# Conceptual Review Agenda

# CSU Parking Garage

**Re:** CSU Parking Garage

**Description of project:** This is a request to build a parking garage on the CSU campus (Parcel #9714413904). The garage will replace an existing portion of a surface parking lot and result in a net gain of 466 parking spots. The proposed garage will be four stories. The parcel is located in the Community Commercial (CC) zone district. This proposal will be subject to Site Plan Advisory Review (SPAR).

**OVERALL SITE  
 UTILITY PLAN**

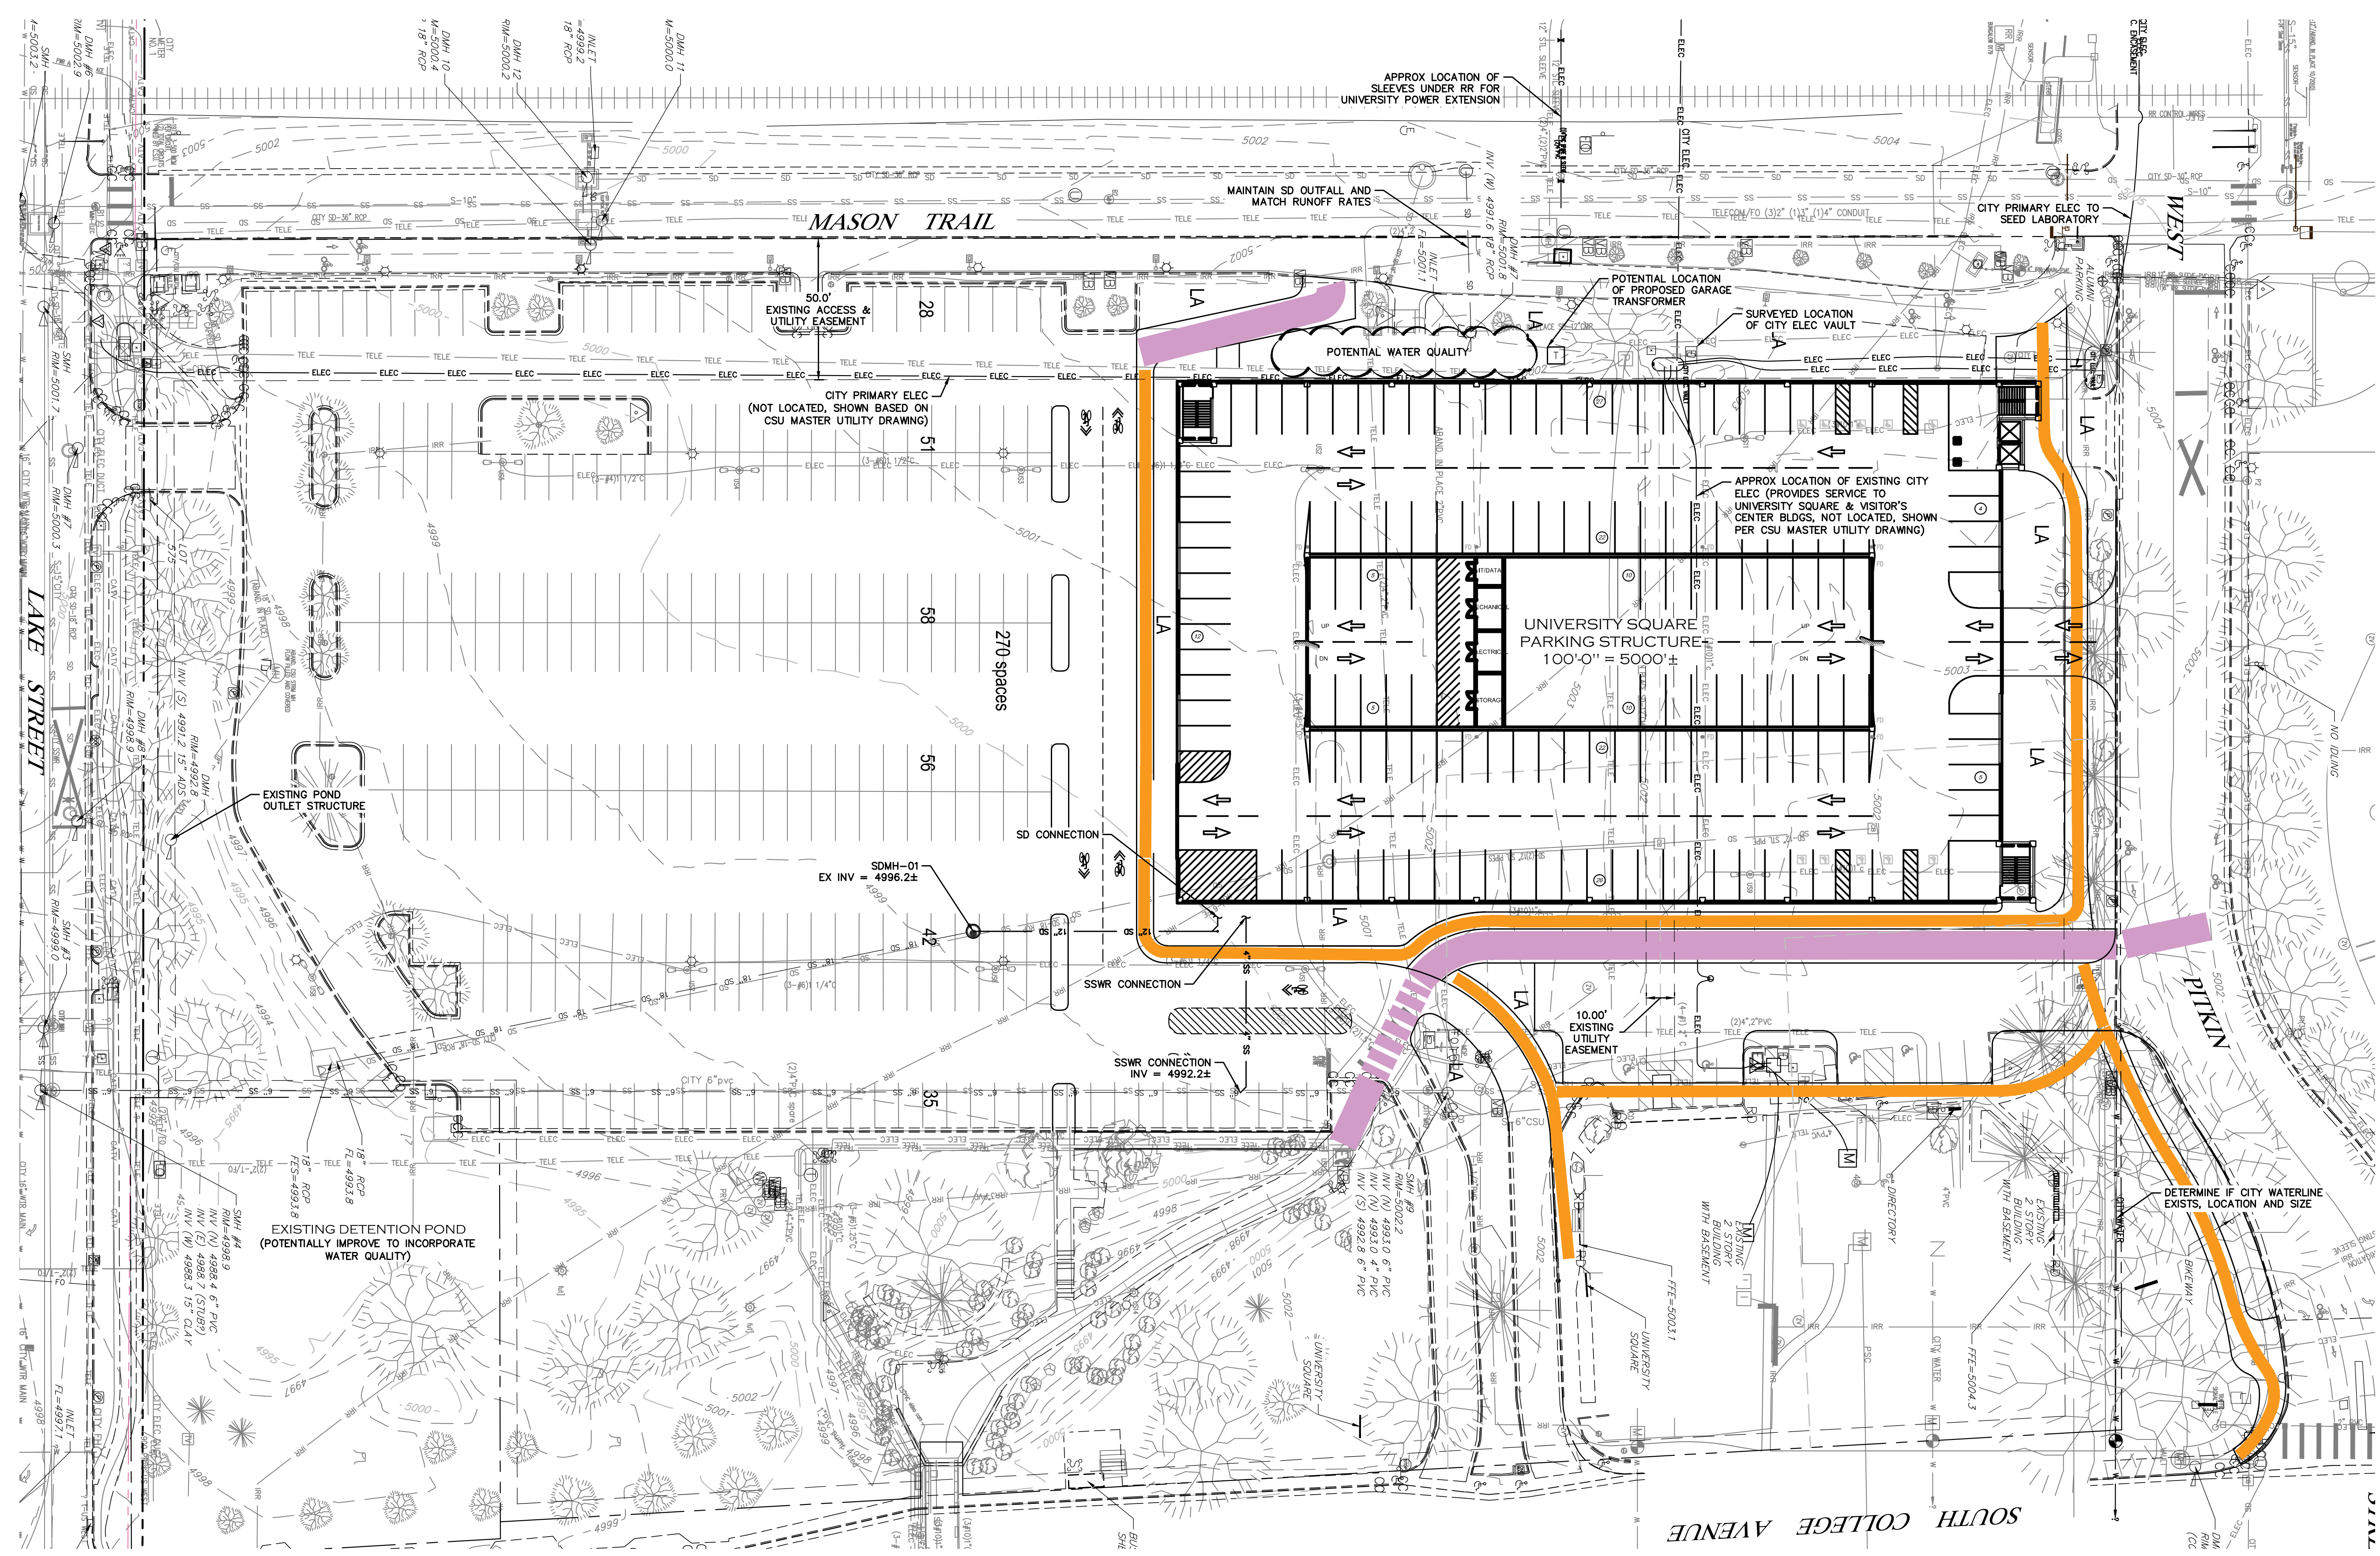
1. It is anticipated no new water or sewer services will be needed with this project. If that changes, please coordinate with Water Utilities Engineering at 970-221-6700.
2. If needed for fire hydrant or fire line installation, the nearest City water main is located in the easternmost lane of College Avenue.

6. It was identified in the conceptual meeting that a City electric line is within an easement across the parking lot where the structure is planned and that the line will need to be relocated around the new structure. A utility easement will need to be dedicated to the City for this line relocation.

1. Light & Power has existing electric facilities running North & South adjacent to the proposed site and also running East & West across the proposed site feeding 1301 & 1311 S. College. Any modification or relocation to the existing electric facilities will be at the applicants expense.
2. Will CSU be providing power to the proposed garage or will the City be providing power?
3. If Light & Power will be providing power a transformer location will need to be coordinated within 10' of an all weather drive-over surface accessible by a line truck.
4. A C-1 Form and a One-line diagram will need to be submitted to Light & Power Engineering with power needs.
5. Electric Capacity fee, Building Site charges, and system modification charges where applicable will apply.  
Contact Light & Power Engineering @ 970-221-6700.

DRAWING TITLE  
**SITE PLAN**

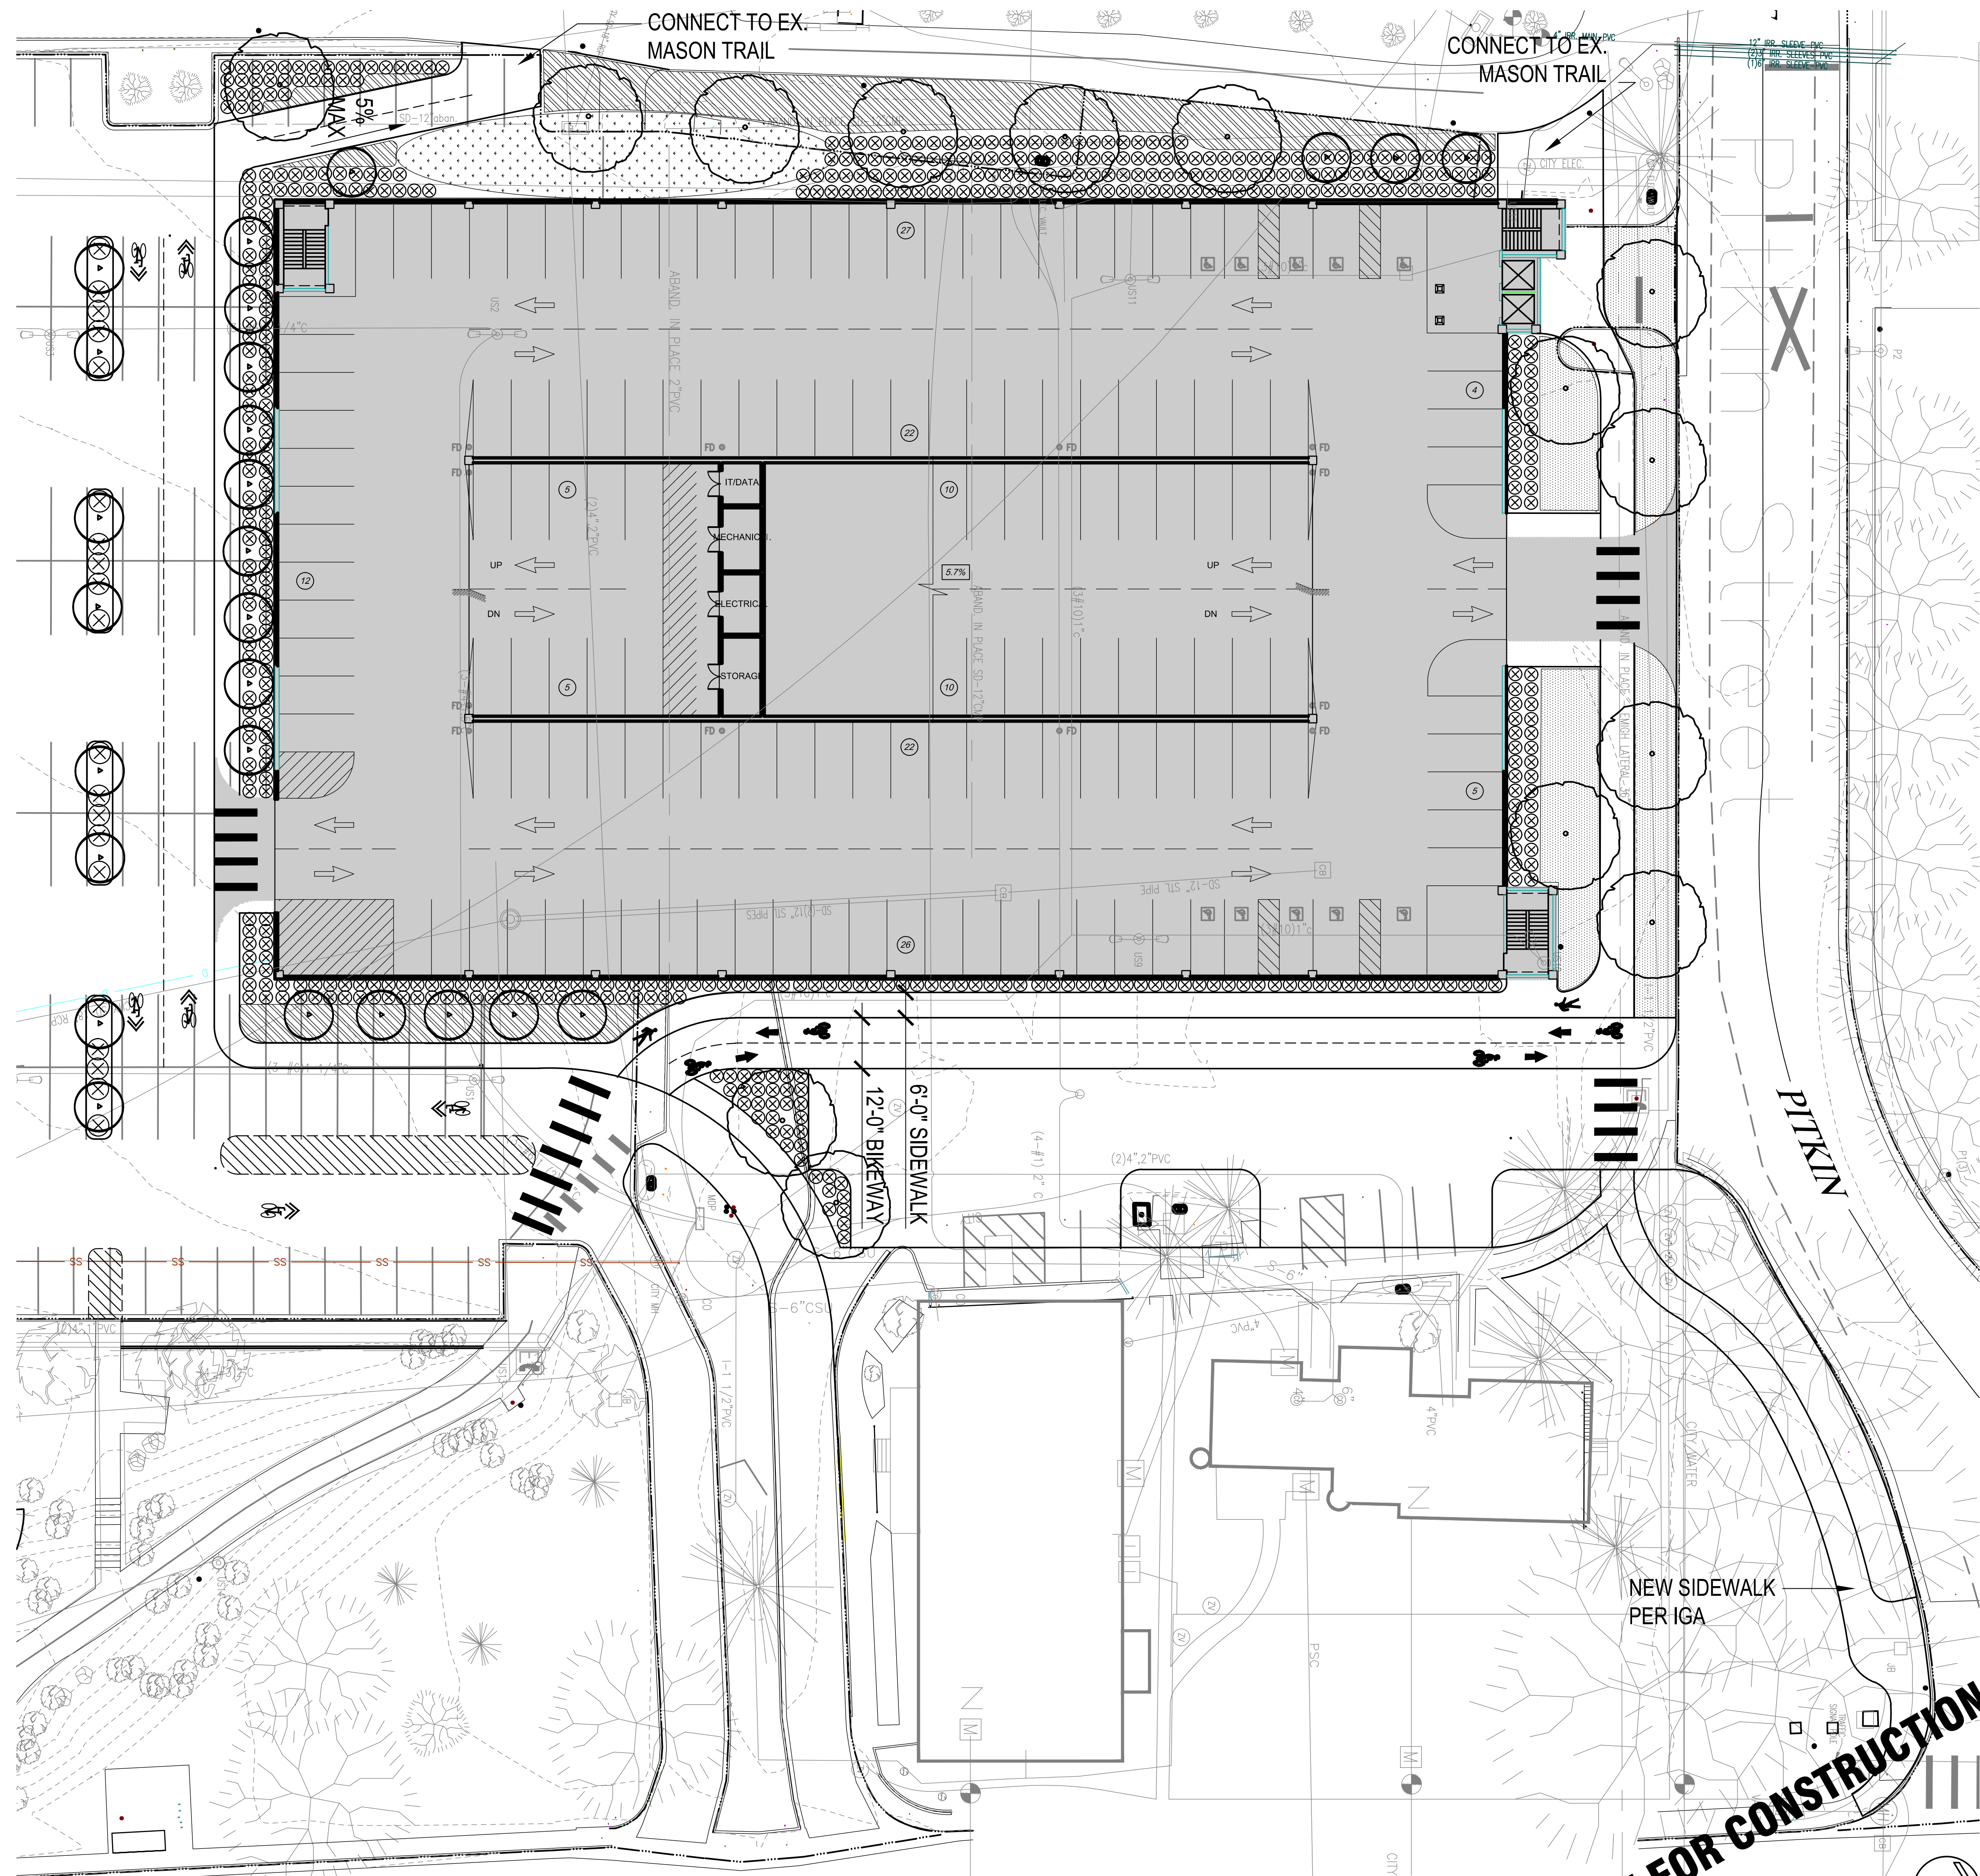
1. We look forward to receiving a TIS to determine the impact of the structure on area City streets.
2. As noted in the kickoff meeting, the trail relocation to the east side of the garage and dumping onto Pitkin mid block is very concerning. With the signal going in at Mason, we believe that is a more appropriate location for peds/bike to cross Pitkin. Revising the layout of the garage to bring the trail from the underpass and along the south side of the garage to the Mason Trail is preferable (not just sharrows, but as a trail south of the drive aisle).

3. The garage entrance on the south side is not aligned with the parking aisles to the south, and appears to have tight turning radius and sight distance issues.

4. It appears that a new access driveway is proposed on Pitkin for just the 7 parking spaces on the east side of the garage. Can the driveway be eliminated and the parking accessed from other directions? Also - if the trail to Pitkin is relocated to south of the garage, then additional parking could be provided in this area.

1. With respect to landscaping and design, the City of Fort Collins Land Use Code, in Article 3.2.1 (E)(2)(3), requires that you use native plants and grasses in your landscaping or re landscaping and reduce bluegrass lawns as much as possible.
2. The applicant should make note of Article 3.2.1(C) that requires developments to submit plans that "...(4) protects significant trees, natural systems, and habitat". Note that a significant tree is defined as a tree having DBH (Diameter at Breast Height) of six inches or more. If any of the trees within this site have a DBH of greater than six inches, a review of the trees shall be conducted with Tim Buchanan, City Forester (221 6361) to determine the status of the existing trees and any mitigation requirements that could result from the proposed development.

4. Engineering, Traffic Operation, and FC Moves met and discussed the bicycle route that you are proposing and we are not fans of the midblock crossing on Pitkin. We think the route would be more effective, efficient and better if the route either curled back to the south and ran along the drive isle to the south of the structure or even if the bikes were directed west along the north side of the structure and then crossed at the controlled crossing at Mason Street.
